City of Aurora Building Division
 Project: **Davita Tenant Improvement**
 Address: **1411 S. Potomac St. # 100**
 Occupancy Group: **B**
 Construction Type: **II 1hr-SPK.**
 RSN: **1322345**
 Permit: **18-1529237 LT**

City of Aurora Building Division
 Reviewed for Code Compliance
 Approved as Noted: **pmckown**
 Date: **Sep 26, 2018**
 2015 INTERNATIONAL CODES & 2017 NEC

Davita
 Aurora Dialysis Center Upgrades
 at
 1411 South Potomac Street, Suite 100
 Aurora, Colorado 80012

DWV FLOOR PLAN

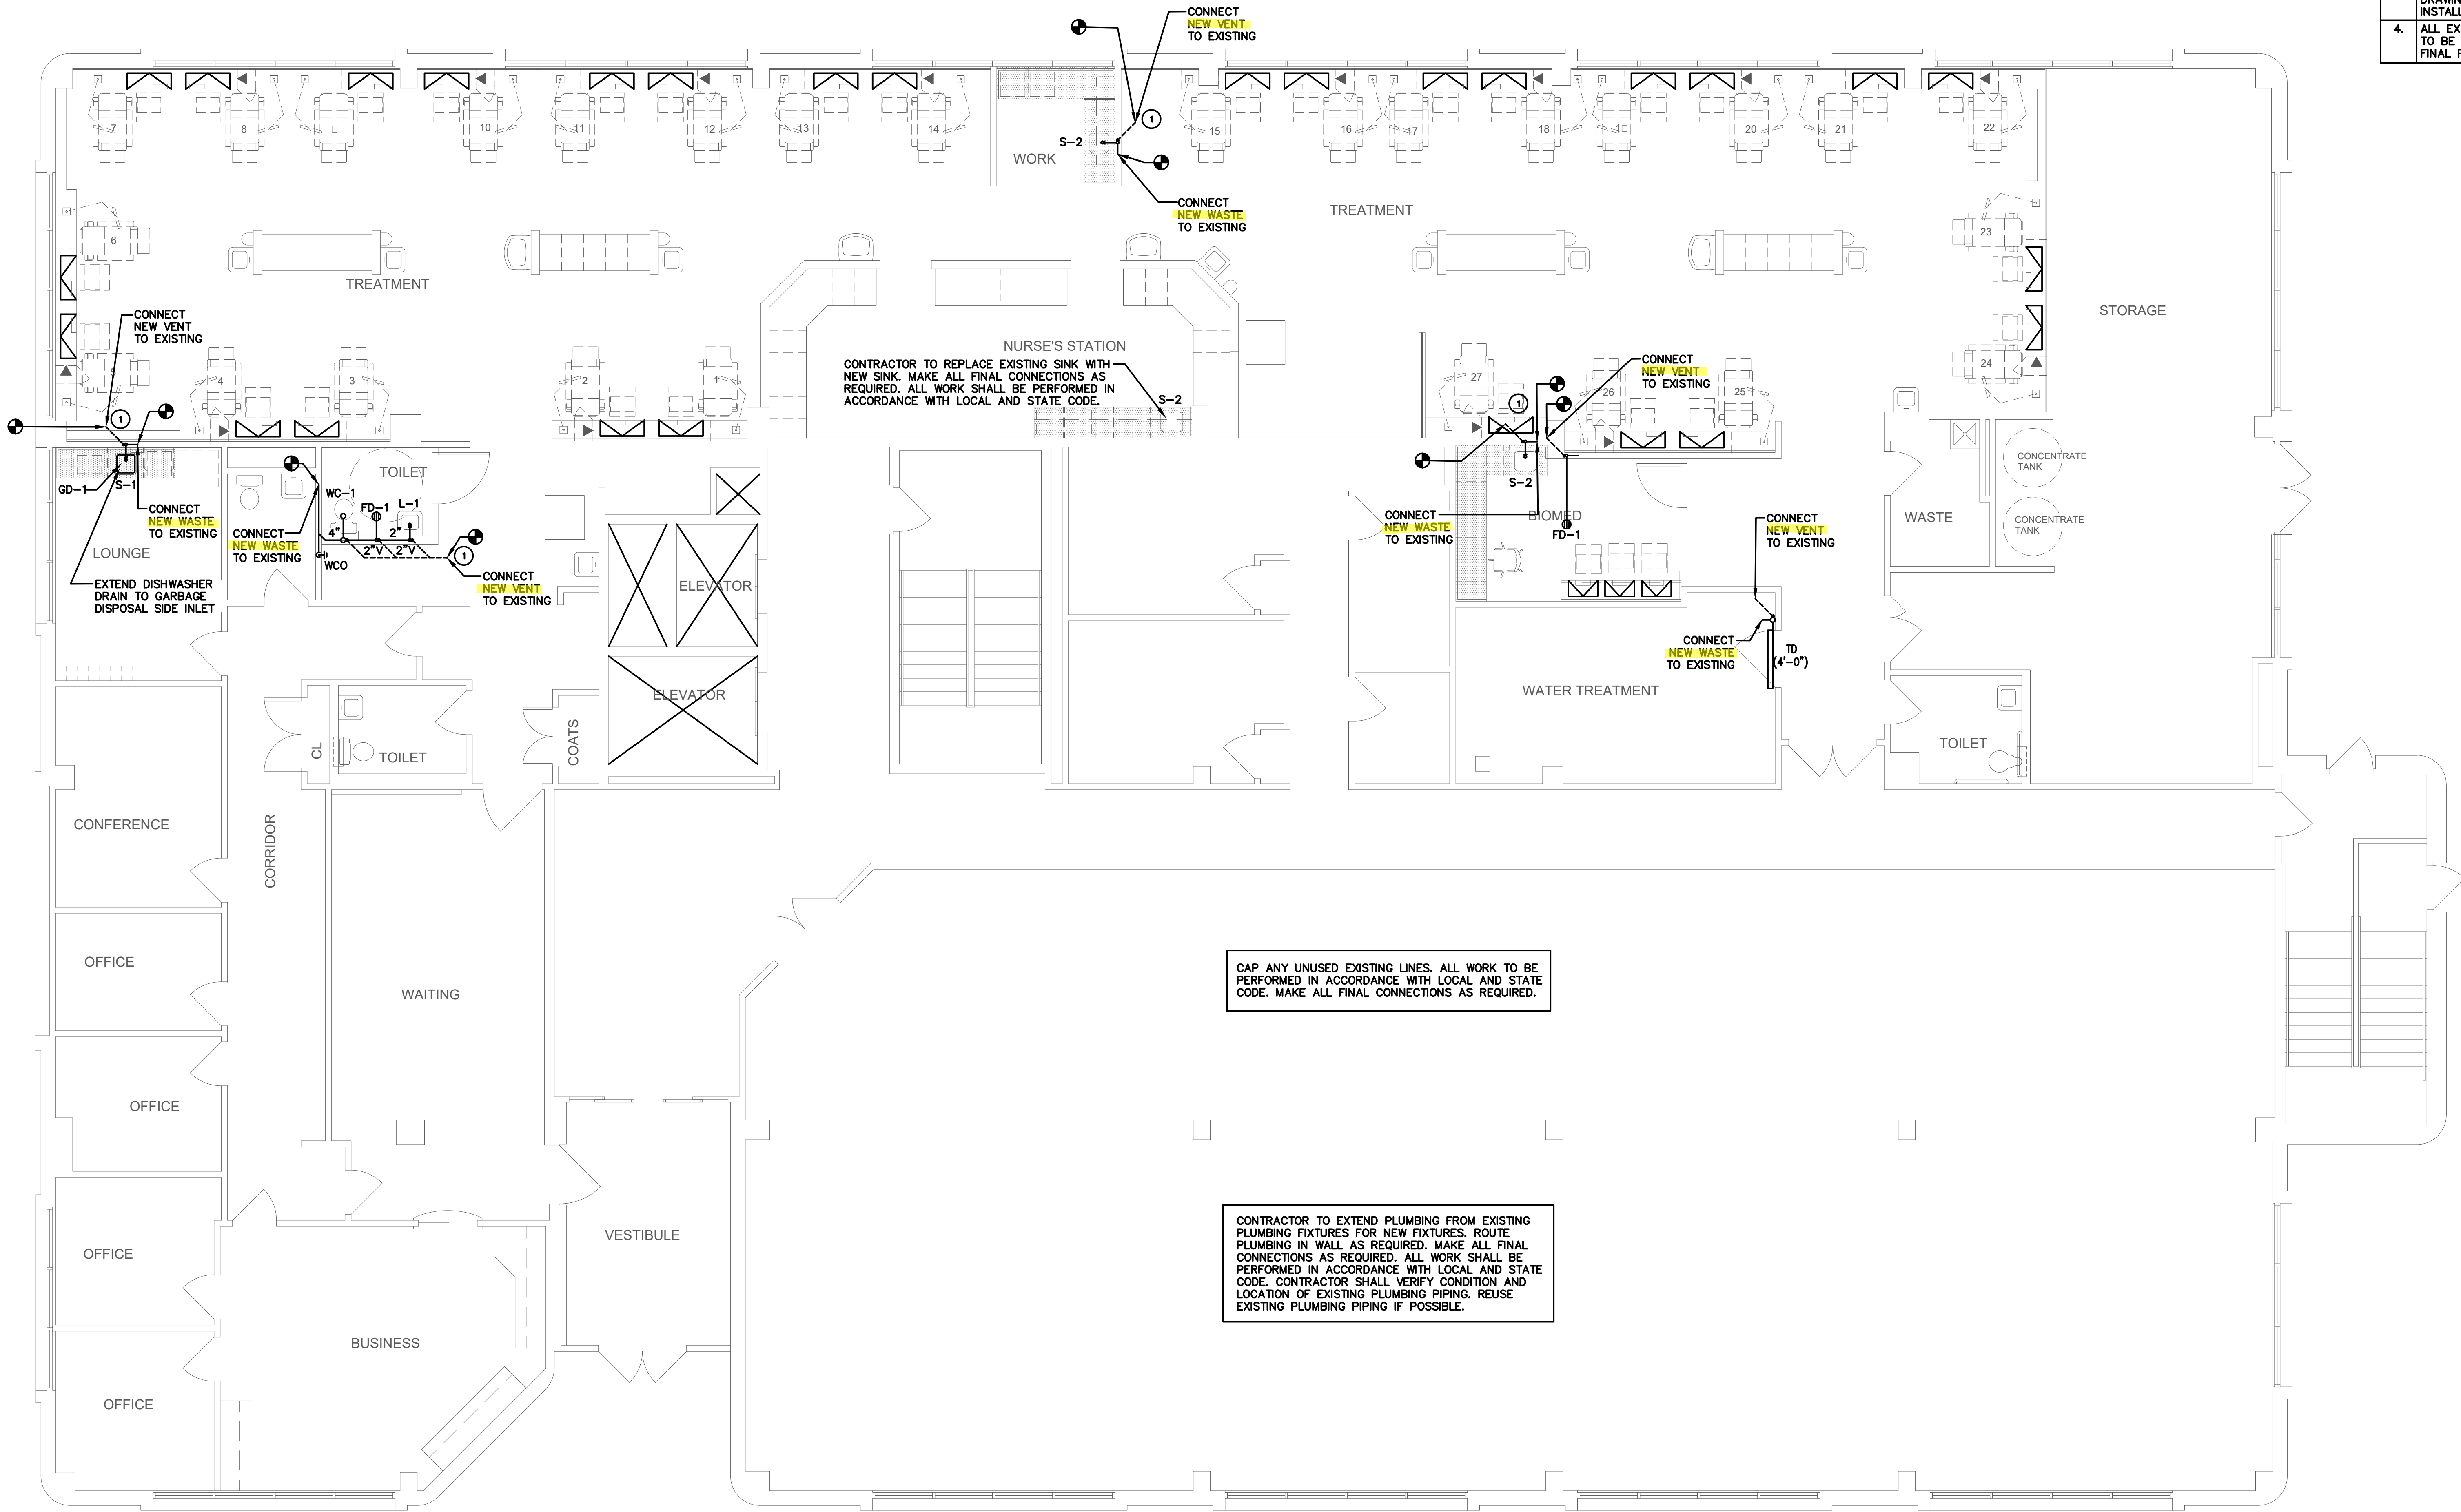
Provide drains no smaller than allowed by 2015 IPC 709.1 and 710.1(1)

The dry vent must rise 6" vertically above the flood level rim of the highest trapped fixture being vented.
2015 IPC 905.4

4 CENTRAL BI-CARB R.O. & B.C. CONNECTION DIAGRAM

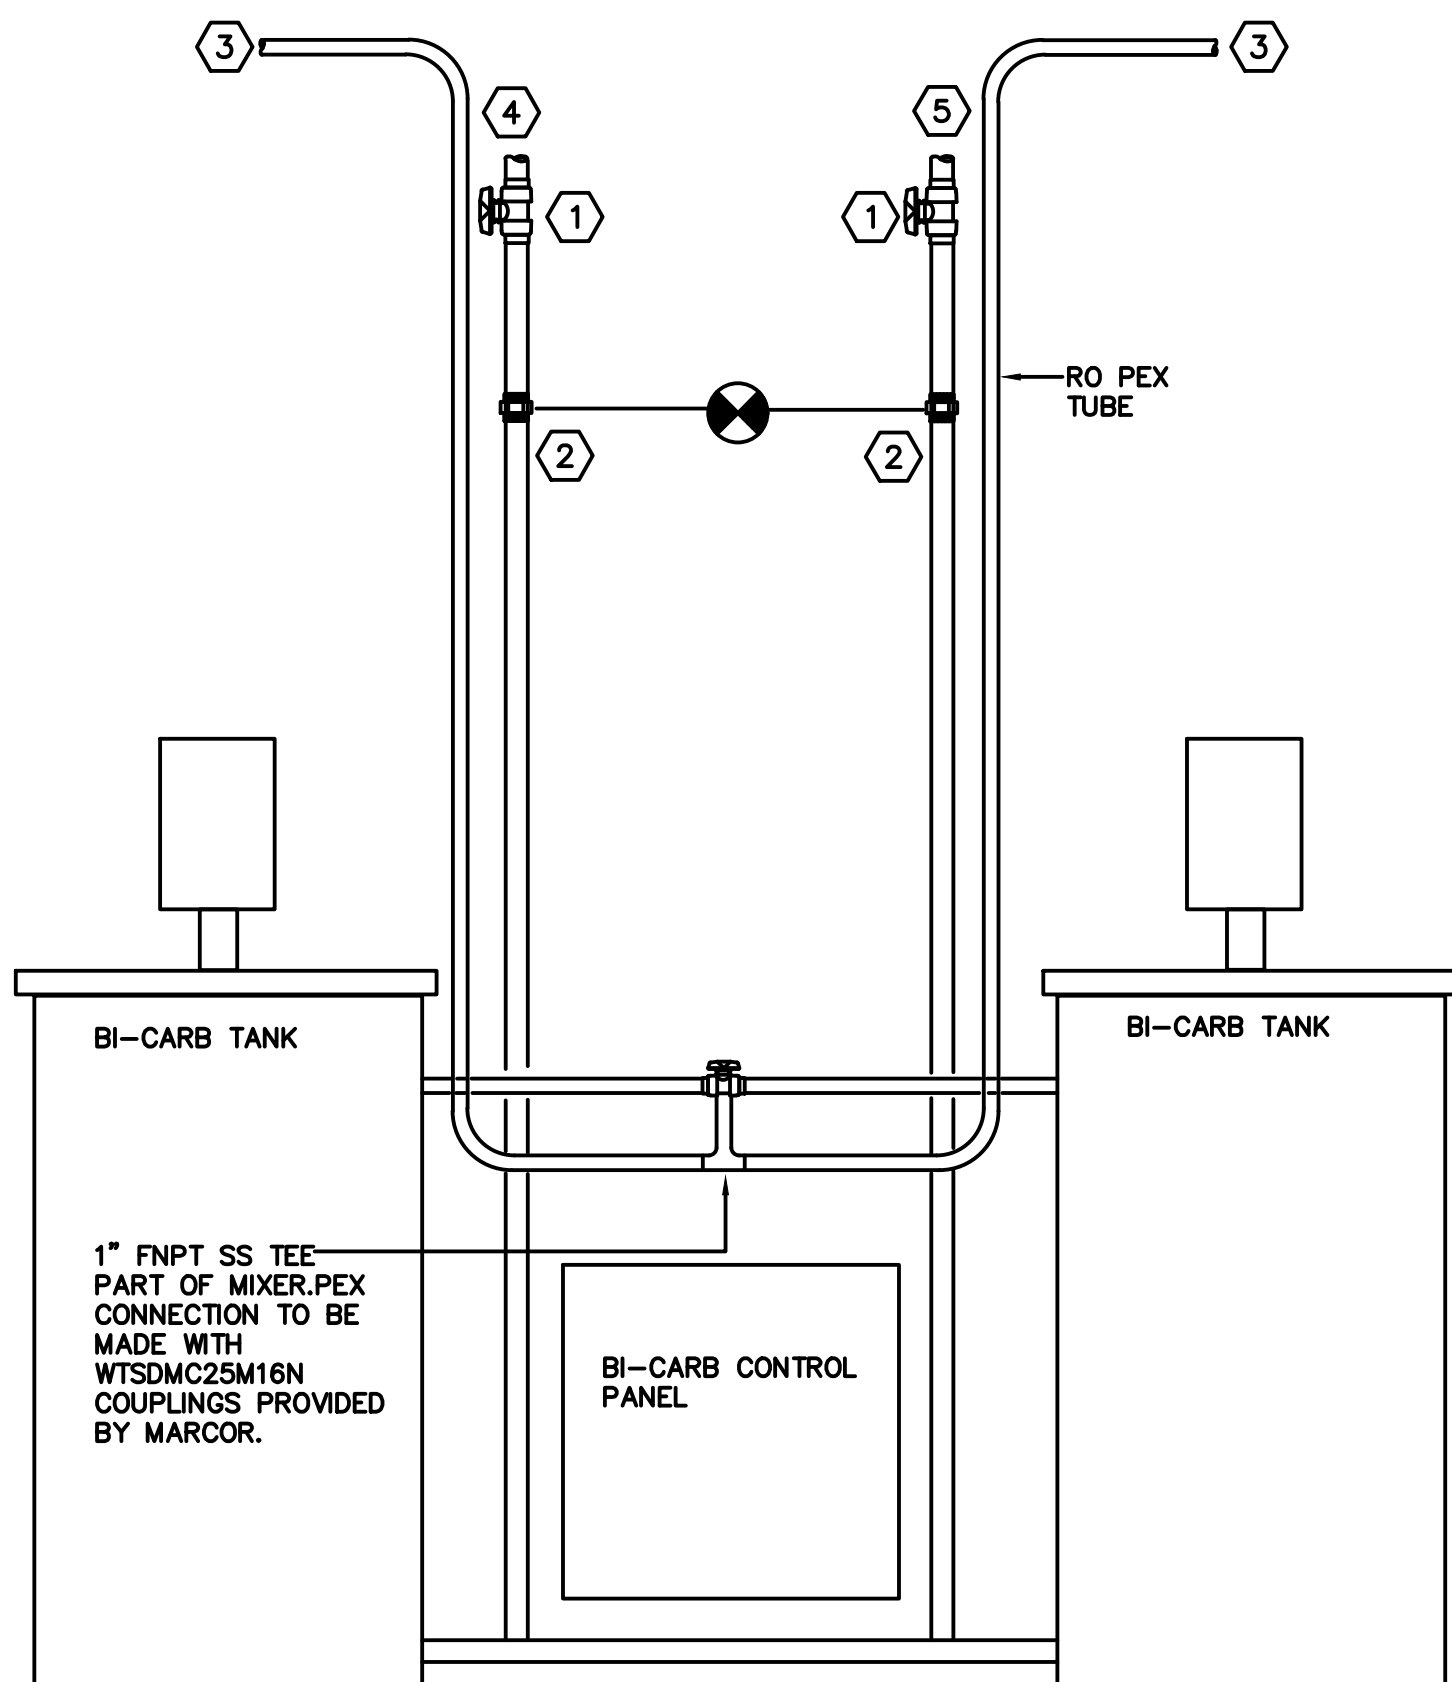
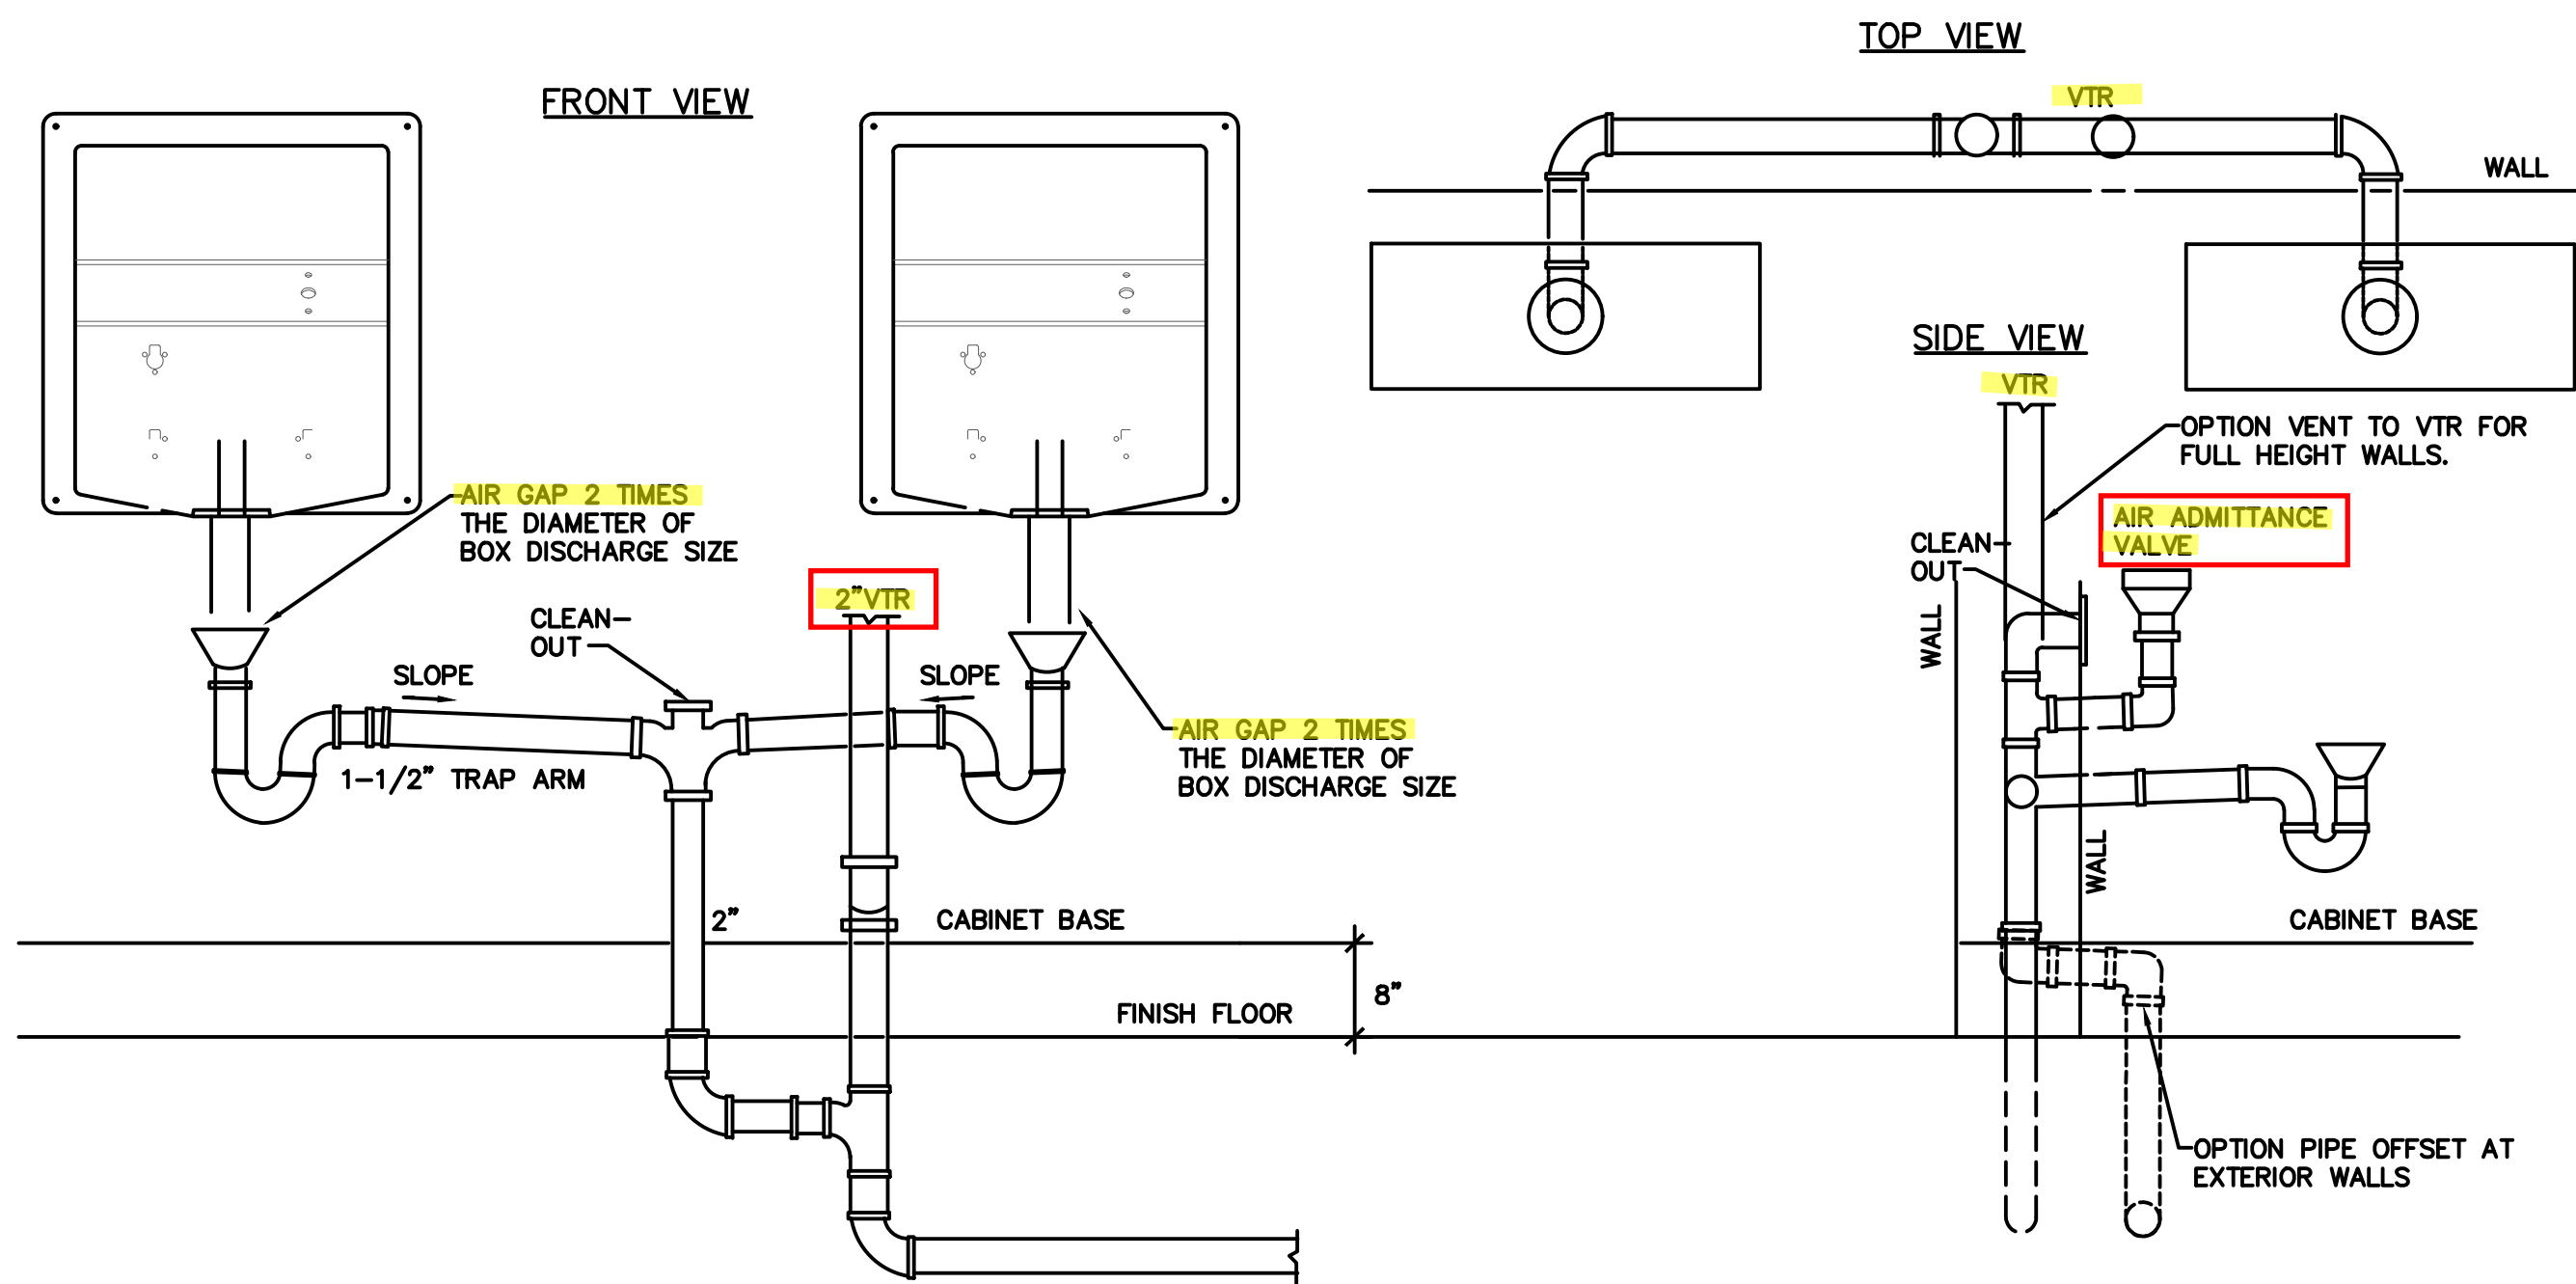
Provide for thermal expansion on hot-water supply system as required by 2015 IPC 607.3 or IRC 2903.4

Provide drains no smaller than allowed by 2015 IPC 709.1 and 710.1(1)

The dry vent must rise 6" vertically above the flood level rim of the highest trapped fixture being vented. 2015 IPC 905.4
